**ITEM 6. DEVELOPMENT APPLICATION: 66-77 EPSOM ROAD ROSEBERY**

**DEVELOPMENT APPLICATION NO: D/2015/624**

**Proposal Summary:** Stage 2 development application for the construction of a 6 to 13 storey mixed use building known as Building A, containing 268 residential apartments, 49 serviced apartments, 1,971sqm of ground floor retail tenancies and 2 levels of basement for 272 vehicles. Landscaping of communal open space and a through site link are also proposed.

**Figure 28:** Original northern elevation

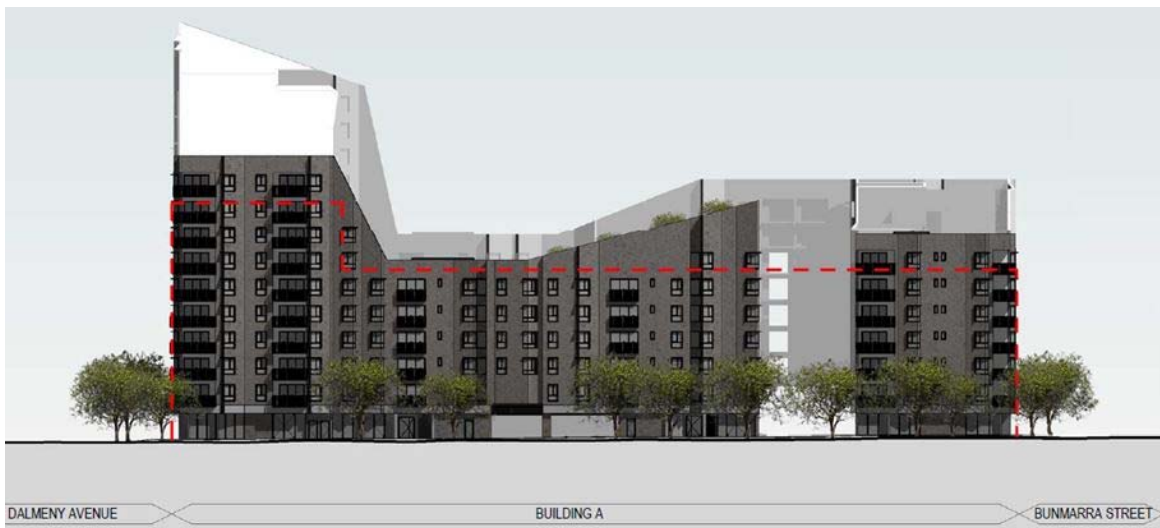
<p>The building form of Epsom Road is 98 metres in length.</p> <p>The building has an opening at the ground and first floor levels for the through site link, however this link is not acknowledged in the architecture above to provide a cue as to where the through site link is and to help visually modulate the building.</p>	<p>The northern facade geometry has been amended between grids 5 and 6 by:</p> <ul style="list-style-type: none"> <li>• Recessing the primary building line between these grids</li> <li>• Recessing the leading edge of the balconies</li> <li>• Creating a more 'angled' façade geometry which is consistent with the overall design concept and competition winning scheme</li> <li>• The angled façade continues up to the roof parapet, meaning that the current continuous line is now broken</li> <li>• Increased the size of the windows between these grids</li> </ul>	<p>Acceptable – the comparison of the original and amended northern facade is included at Figures 28 - 29 below</p>

**Figure 29:** Amended northern elevation

**Figure 33:** Amended southern elevation

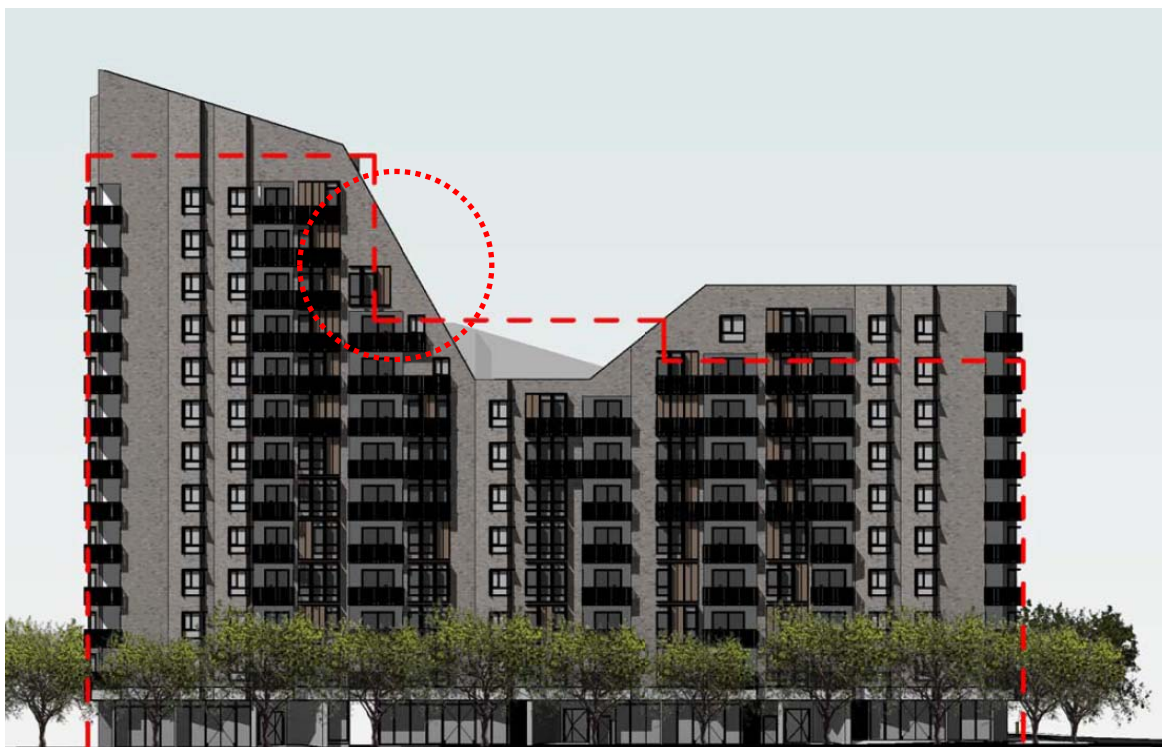
Issue	Applicants response	Comment
<p>The tower element is not as slender as it was in the competition winning scheme. It is suggested that the treatment of the tower be reconsidered to make it appear more slender.</p>	<p>The depth and angle of the tower elements have been reduced to improve the slender appearance of the tower.</p>	<p>Acceptable</p>
<p>Individual air conditioning units are provided on balconies. This is contrary to the SDCP 2012 which requires centralised heating and cooling infrastructure.</p>	<p>The air condition units have been consolidated in areas in the basement, roof voids, and roof.</p>	<p>Acceptable</p>
<p>The original plans showed a roof void in the tower at level 10, resulting in a triangular form of brickwork on the west elevation which allowed a clear reading of the sloping roofscape. A one bedroom unit is now located in this area and a window is located in what was a defined triangular area of brickwork. This reduces the appearance of the tower and the elevation needs some areas of brick without fenestration to best show off the building form.</p>	<p>The intention of the design concept is to increase the diversity and amenity of the apartment types by utilising the space/volume underneath the sloping wall/roof areas. The sloping roof creates interesting and different spatial volumes which are not typically present in contemporary apartment design. In addition, the sloping wall areas have a hit and miss brickwork pattern utilising glass bricks to bring natural light into the apartments from another side. As such, these have the potential to be unique apartments with a very high level of amenity.</p>	<p>On balance the inclusion of a unit in this location is acceptable given the amenity of the unit.</p> <p>This area is shown as originally proposed and as amended in Figures 34 and 35.</p>

Figure 36: Approved Stage 1 DA heights compared to proposed

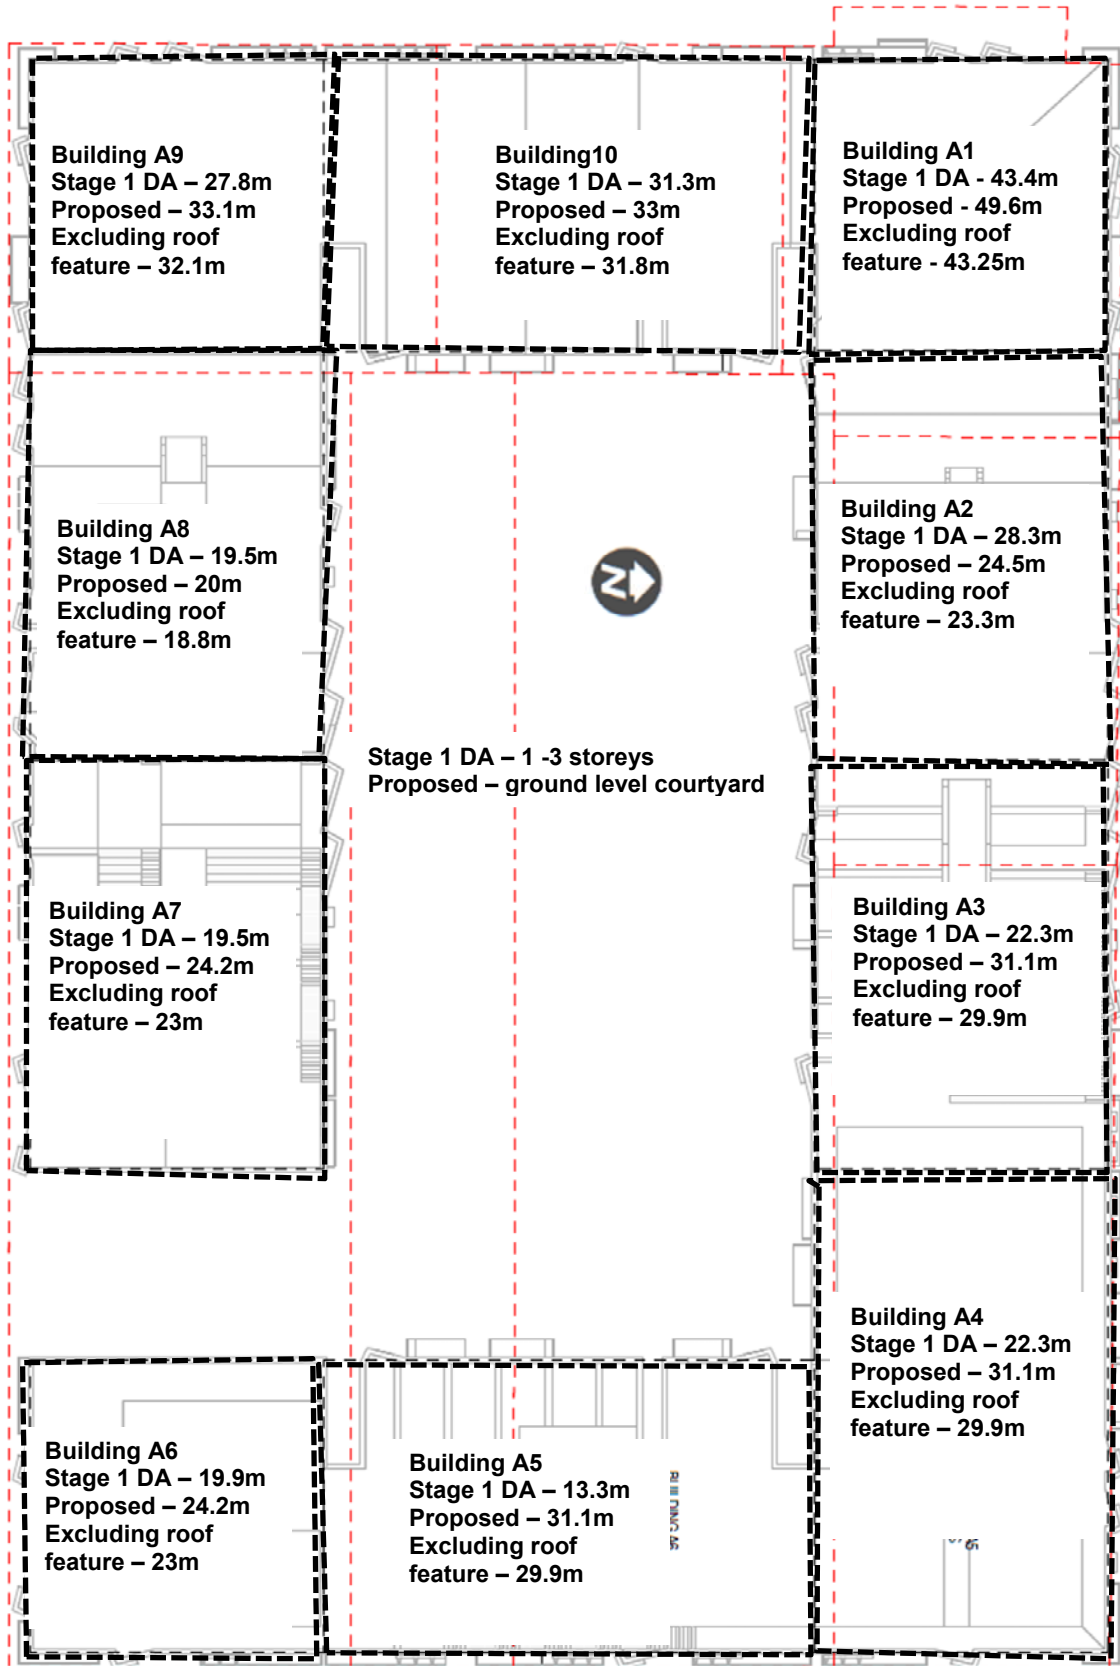
A4	0 – 22.3	<b>31.1</b>	29.9	<p>Stage 1 DA did not exceed the 29m height control.</p> <p>The proposal exceeds the 29m height control by 2.1m in total, or 0.9m if excluding the roof feature. This exceedance is minor in the context of the overall development and will not cause any unreasonable impacts.</p>
A5	4.4 – 13.2	<b>31</b>	29.8	<p>Stage 1 DA did not exceed the 29m height controls.</p> <p>Proposal exceeds the 29m height control by 2m in total, or 0.8m if excluding the roof feature. This exceedance is minor in the context of the overall development and will not cause any unreasonable impacts.</p>

Stage 2 DA Building No.	Approved Height (Stage 1 DA)- Not including plant and roof feature	Proposed height to top of roof in meters	Total height excluding architectural roof feature	Comment
A6	19.9	24.2	23	Both the Stage 1 DA and the proposal do not exceed the 29m height limit.
A7	19.5	20-27.9	18.8 – 22.31	Both the Stage 1 DA and the proposal do not exceed the 29m height limit.
A8	19.5	20	18.8	Both the Stage 1 DA and the proposal do not exceed the 29m height limit.
A9	27.8	<b>33.3</b>	32.1	<p>The Stage 1 DA did not exceed the 29m height control.</p> <p>The proposal exceeds the 29m height control by 4.3m in total, or 3.1m if excluding the roof feature. This exceedance is minor in the context of the overall development and will not cause any unreasonable impacts.</p>
A10	31.3	26.7- <b>33</b>	25.5 – 31.8	<p>The Stage 1 DA already exceeded the 29m height control by 2.3m (not including plant and roof features).</p> <p>The proposed height exceedance of 4m (including roof feature) or 2.8m if excluding roof feature. This exceedance is minor in the context of the overall development and will not cause any unreasonable impacts.</p>

70. It is considered that the written statement provided by the applicant has sufficiently justified that strict numeric compliance with the development standard is unreasonable and unnecessary in this instance, given the Stage 1 DA approval, and have provided sufficient environmental planning grounds to justify contravening the development standard. The proposal is consistent with the building height control and B4 Mixed Use zone objectives and will be in the public interest.
71. For the reasons outlined above, there are sufficient planning grounds to justify the departure from the height development standard and it is recommended that a Clause 4.6 exception be granted, pursuant to the Director-General's general concurrence of May 2008.
